PREVOST

WARRANTY BULLETIN

WB16-02C

DATE :	MAY 2016	SECTION :	06 - Electrical
EXPIRATION:	MAY 2018		
SUBJECT :	CHARGING SYSTEM IMPROVEMENT

FIGURE 7

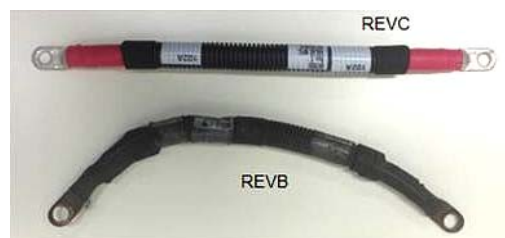
Rev.C lug terminal through hole dia.= 5/16" CORRECT

Rev.B lug terminal through hole dia.= 13/32" INCORRECT

Rev.B diameter of the through hole is too large, reducing contact surface with the stud and the nut thus reducing electrical conductivity between the lug and the alternator stud (FIGURE 7).

FIGURE 8

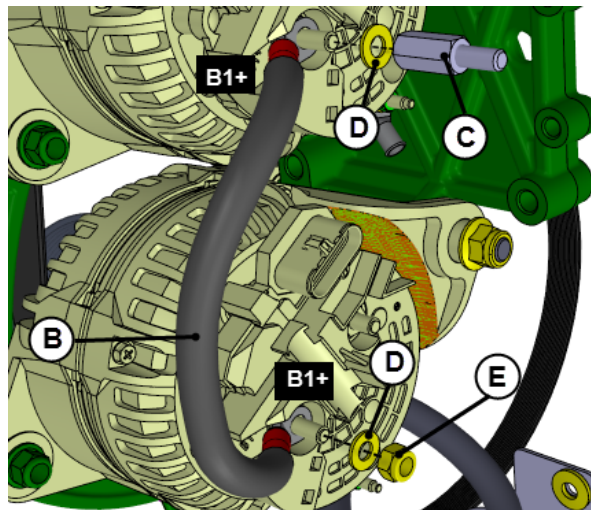
7. Reinstall appropriate jumper cable **B** (i.e. rev.C) with appropriate stud adapter. Refer to FIGURE 8.

B : JUMPER CABLE #067835 revision C

C : STUD ADAPTER #564590 torque: 10 lbf-ft

D: FLAT WASHER #5001341

E: NUT M8 #5001787 torque: 10 lbf-ft

FIGURE 11

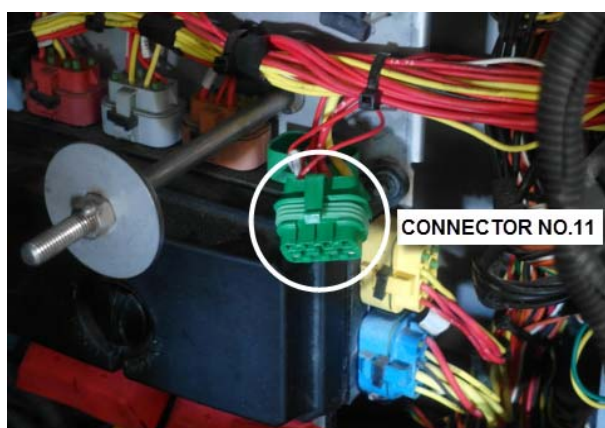
3. Using an extractor tool or a small flat blade screwdriver, remove wire 24VDALT from cavity H of connector no.11 (FIGURE 11 to FIGURE 14).

FIGURE 16 : WIRING DIAGRAM PAGE 5.1

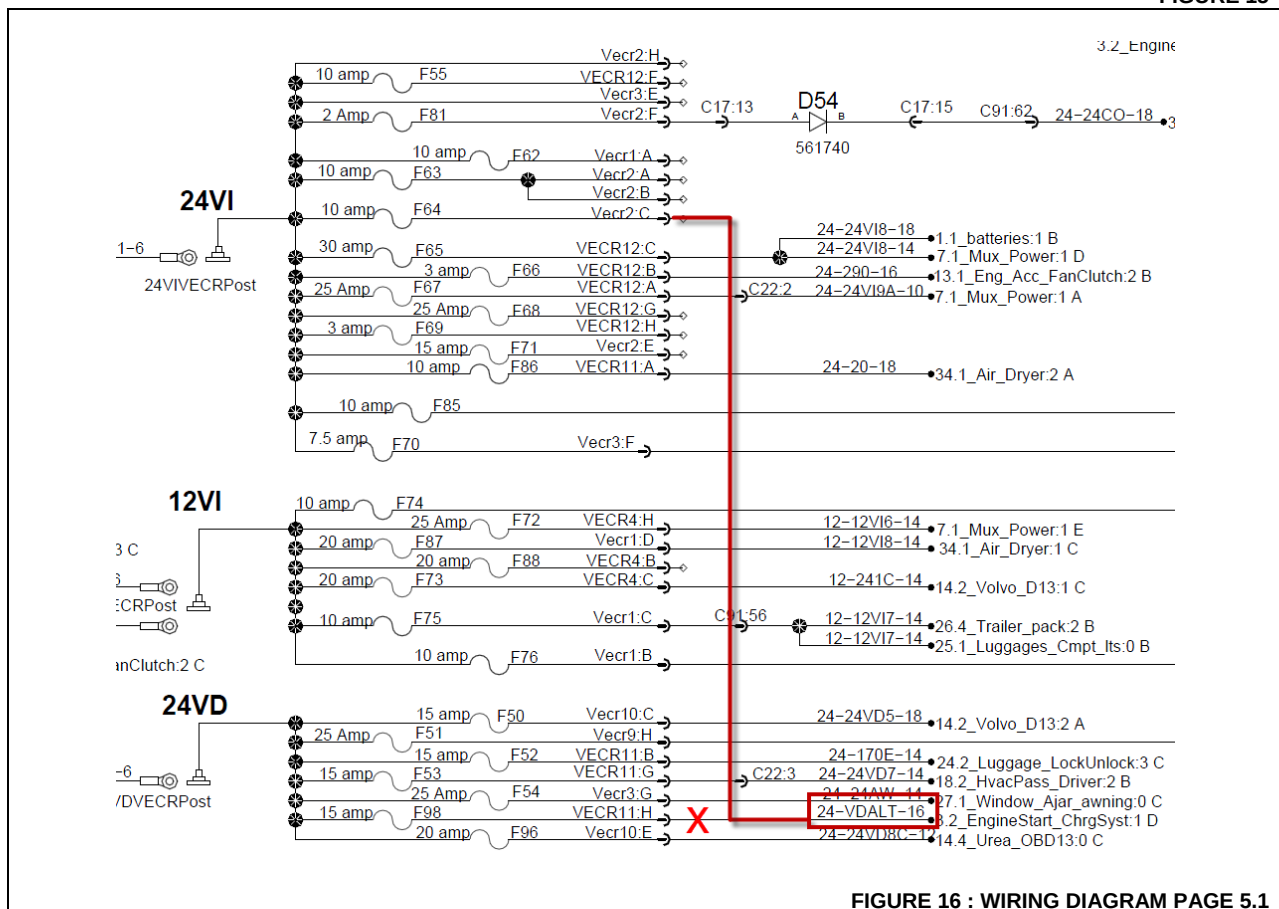
4. Relocate wire 24VDALT to cavity **C** of connector no.2 (red) on the harness.

Cavity **C** of connector no.2 should be available. This branch of the circuit will be protected by 10A fuse F64 (see FIGURE 16 below).

Should cavity C not be available, refer to your vehicle wiring diagram page 5.1 to select another free cavity protected by a 10A or 15A fuse (see FIGURE 16 for reference).

FIGURE 20

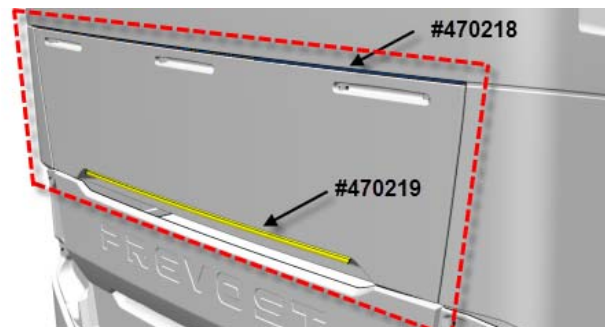
2. Clean dirt on the lower part of the **exhaust aftertreatment system ATS** access hatch as well as the area located right above the ATS access hatch (FIGURE 20). It is very important to install the drip edge on a clean surface to assure water tightness.

NOTE: FIGURE 20 shows where the drip edges will be installed.

FIGURE 40

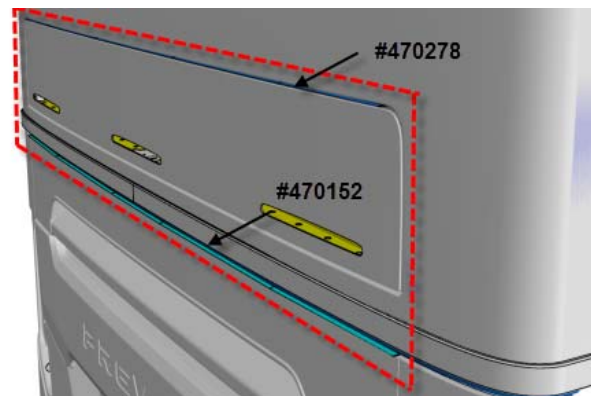
2. See on FIGURE 40 where each drip edge will be positioned. The drip edges will be fastened on the vehicle body, **not on** the ATS access hatch.
